MONTEREY PENINSULA WATER MANAGEMENT DISTRICT

**ADDENDUM NO. 1
TO
CONTRACT DOCUMENTS**

**For Construction
Of
BACKFLUSH BASIN EXPANSION PROJECT**

This Addendum (including attachments), dated August 30, 2018, includes 19 pages.

DEMOLITION AND FINAL GRADING PLAN
MONTEREY PENINSULA WATER MANAGEMENT DISTRICT
SANTA MARGARITA ASR FACILITY SITE EXPANSION
1910 GENERAL JIM MOORE BOULEVARD

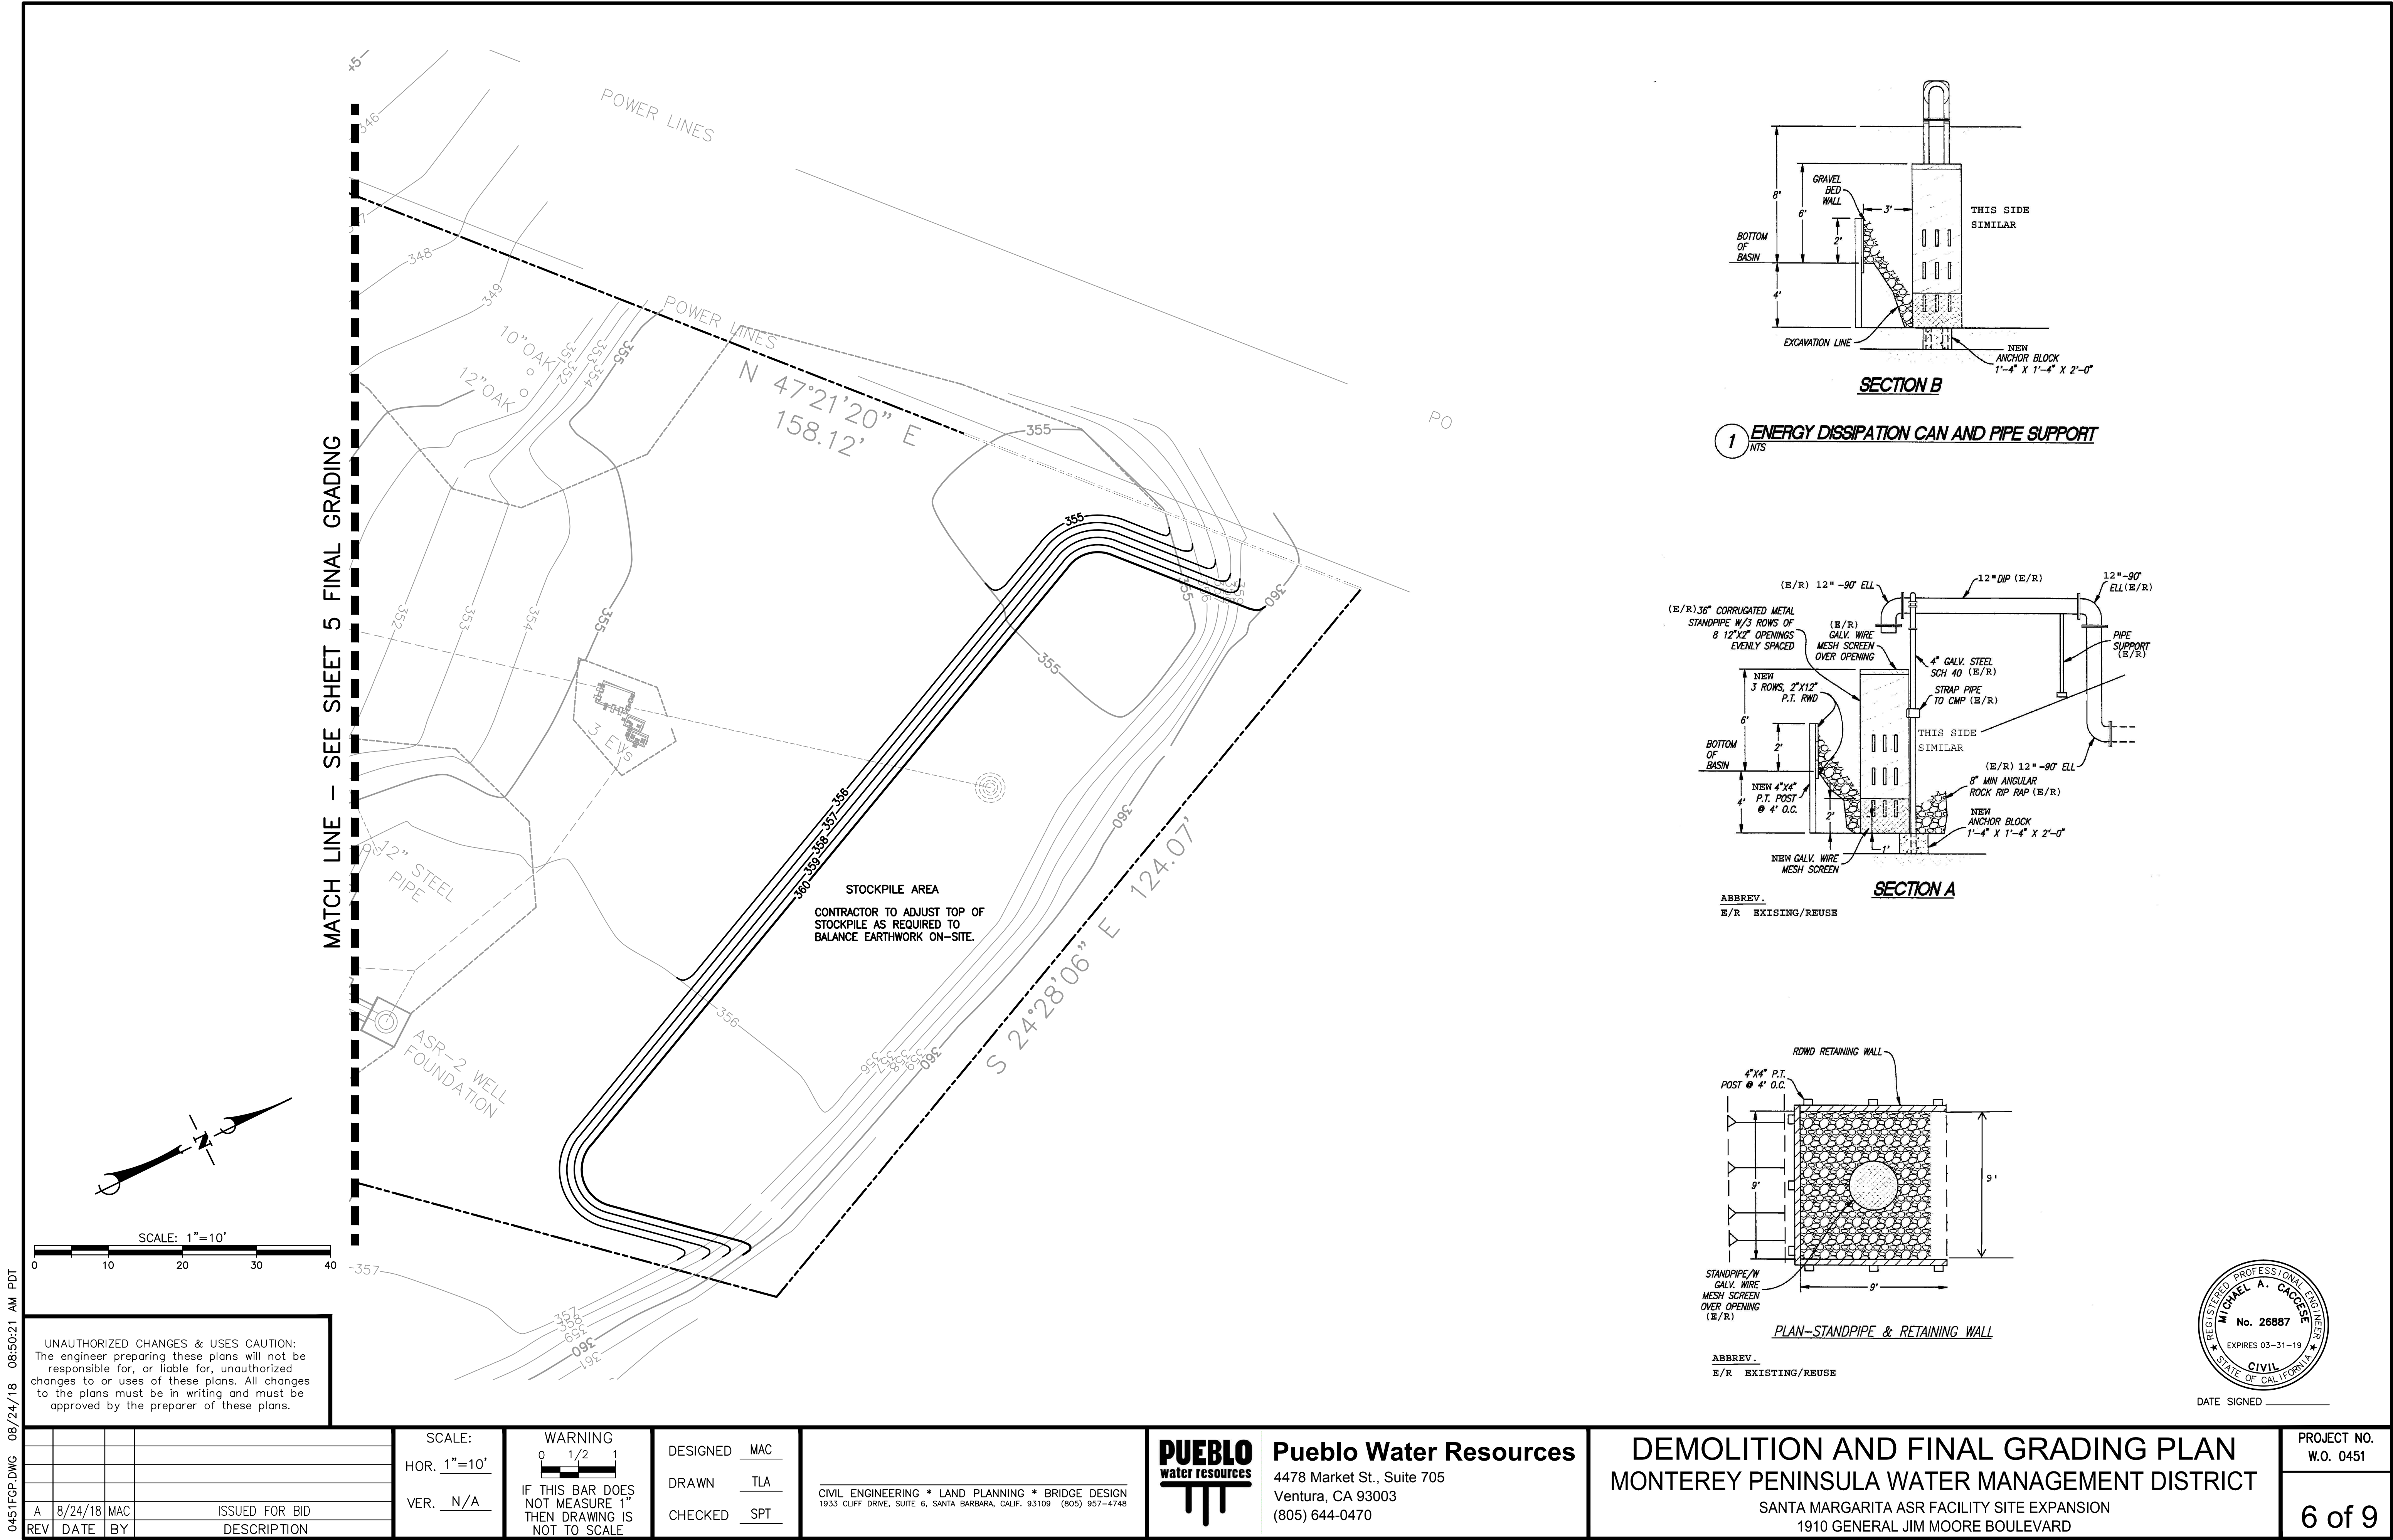
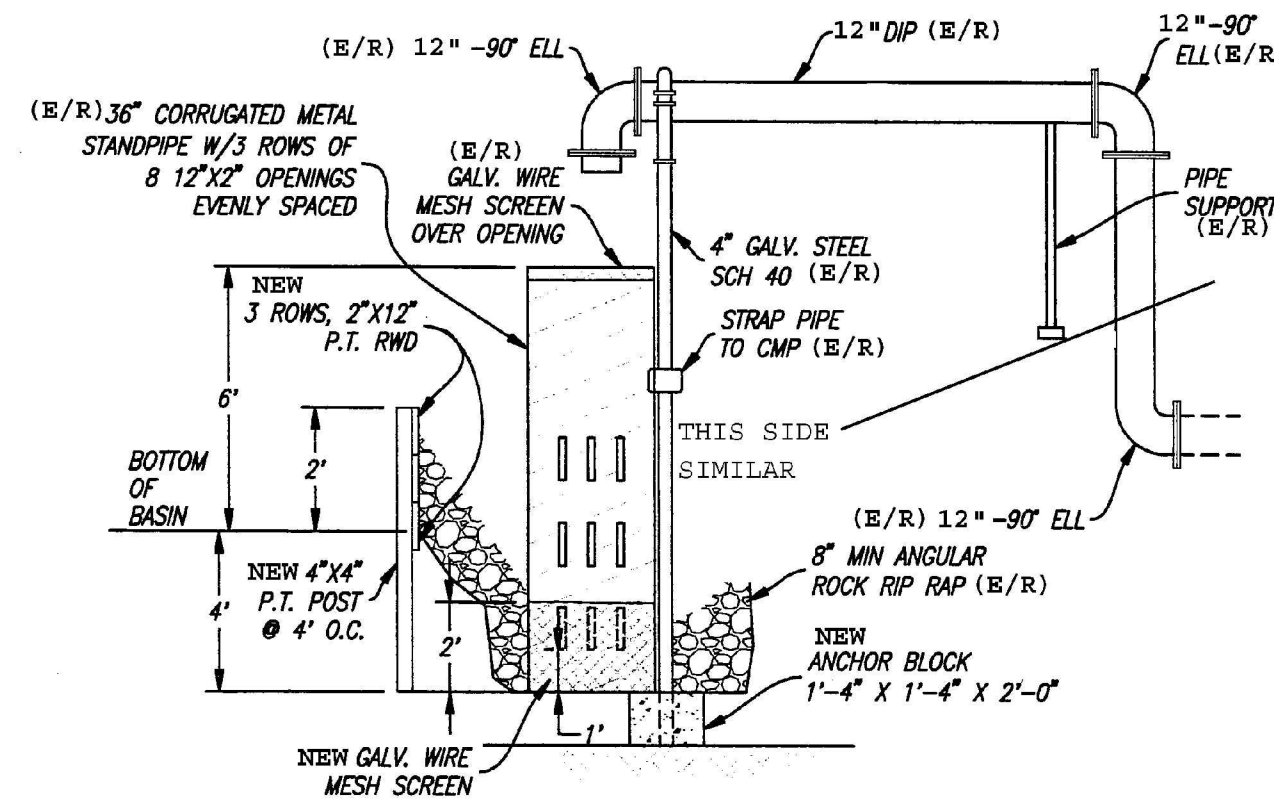
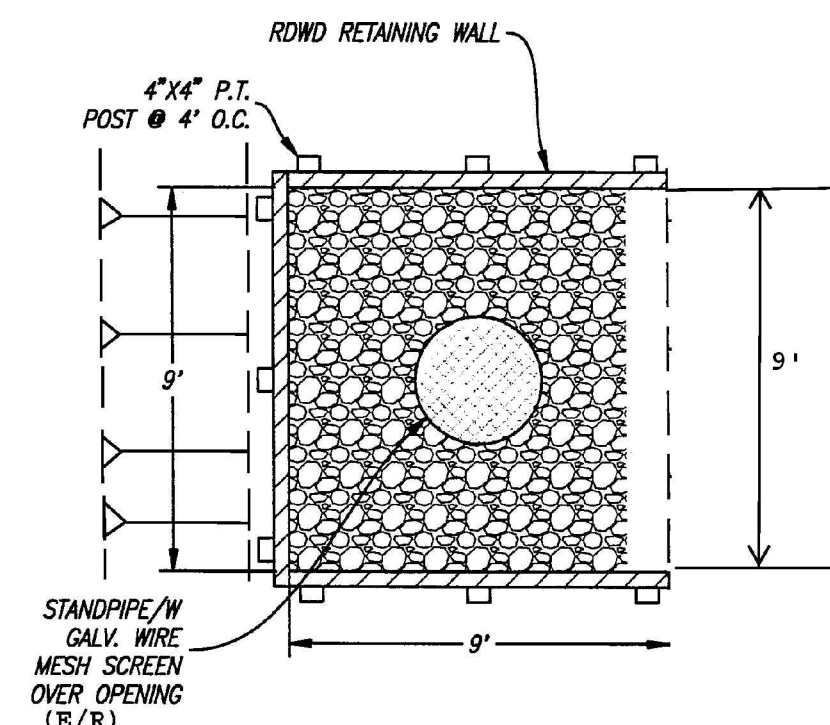
Drawings and Specifications, Drawing 6

Add the following Note:

Drawings and Specifications, Drawings 5 and 6

Add the following note:

The stockpile may not be taller than five (5) feet.

The price to furnish or provide new materials shall be included in the bid price.
